Staff Report File Number: PC 19-039

GLUA-18-00038- Consolidated File (No. SUB-18-00001: Subdivision, NROD-18-00012: Natural Resource Overlay District, VAR-18-00003: Variance - Planning Commission Type III) for a property located at 16362 Hiram Ave, Oregon City.

TYPE III SUBDIVISION, NATURAL RESOURCE REVIEW AND PLANNING COMMISSION VARIANCE STAFF REPORT AND PROPOSED CONDITIONS OF APPROVAL

REQUEST: Approval of a 5- Lot Subdivision located within the Natural Recourses Overlay District including a Planning Commission Variance for corner side setback reduction for Lot 1 and modifications to allow an offset intersection and reduced street width.

Figure 4: Existing Conditions – Existing house to remain on Lot 1- location of sideyard setback reduction Variance request.

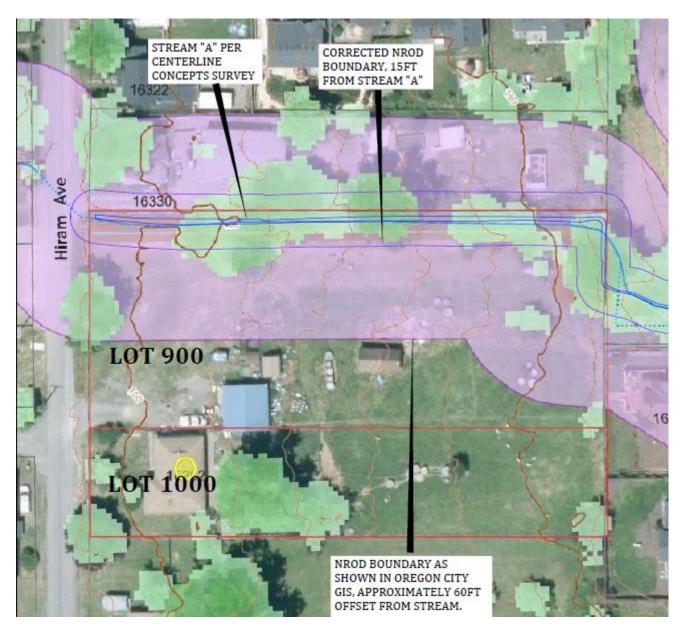
The final, and needed, adjustment is a Planning Commission Variance to the corner side setback on Lot 1. This is the minimum required reduction for the corner side yard setback of Lot 1. Denial of this request would require the applicant to demolish the existing modest house onsite and removal of entry level housing stock from the city's housing inventory.

17.60.030.C. Granting the variance will equal or exceed the purpose of the regulation to be modified. **Finding: Complies as Proposed.** The proposed Variance is a balance of different competing regulations as noted in B above. The proposed Variance will overall provide a reasonable compromise, of competing requirements.

Figure 5: Proposed Site Plan

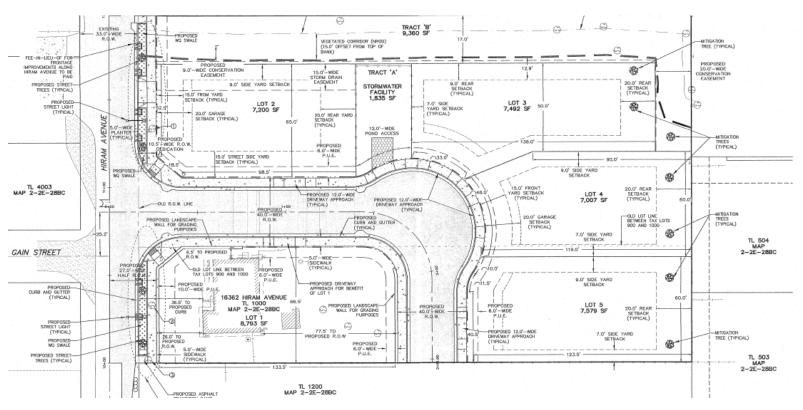
The applicant is additionally applying for a Planning Commission Variance for corner side setback reduction from 15 to 6 feet for the existing house on Lot 1 and a Type II modification requests to allow a constrained street and to increase the intersection centerline offset distance to 24.9 feet to allow an offset intersection and reduced street width.

- 1. The applicant shall schedule a pre-design meeting with Public Works Development Services staff prior to initial submittal of construction plans. (DS)

- 2. The applicant shall provide construction plans, stamped and signed by a professional engineer licensed in the State of Oregon, containing street, grading, stormwater, sanitary sewer and water infrastructure improvements that conforms to all current Oregon City Public Works standards, specifications, codes, and policies for review and approval by the City.

- 5. The applicant shall provide street lights along Hiram Avenue and the new road in conformance with all City standards, specifications, codes, and policies and as approved by Portland General Electric (PGE). The applicant shall submit a photometric plan. (DS)

- 20. The applicant shall provide the following along the frontage of Hiram Avenue on the subject property side of the centerline:
 27' of ROW consisting of 16-foot-wide pavement, 0.5-foot-wide curb, 5-foot-wide landscape strip, 5-foot-wide sidewalk and a 0.5-foot-wide buffer strip. (DS)

- 22. For the proposed dead-end street, the applicant shall provide a turnaround contained in an easement with appropriate no-parking signs or markings for large emergency vehicles and other long vehicles in the form of a hammerhead or other design in accordance with Clackamas Fire District No. 1 and City adopted street standards. (DS)

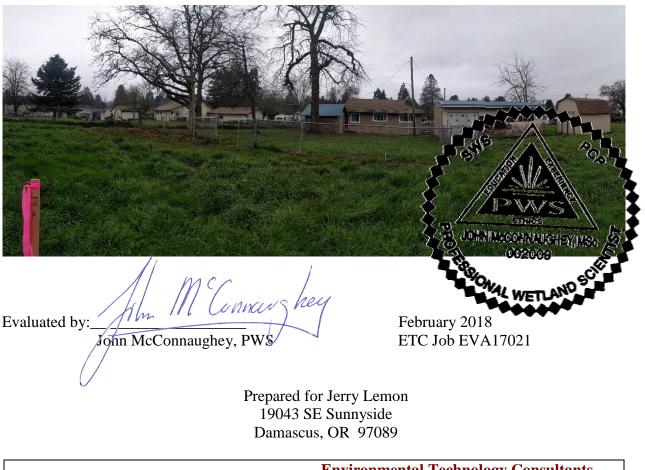
Finding: Complies as Proposed. Fencing along the ROW line could be installed, or vegetation screen could be planted although the applicant notes that side of the existing home has no windows or doors. Staff is not

requesting any mitigation with this proposal and will look to the Planning Commission for additional direction on this issue.
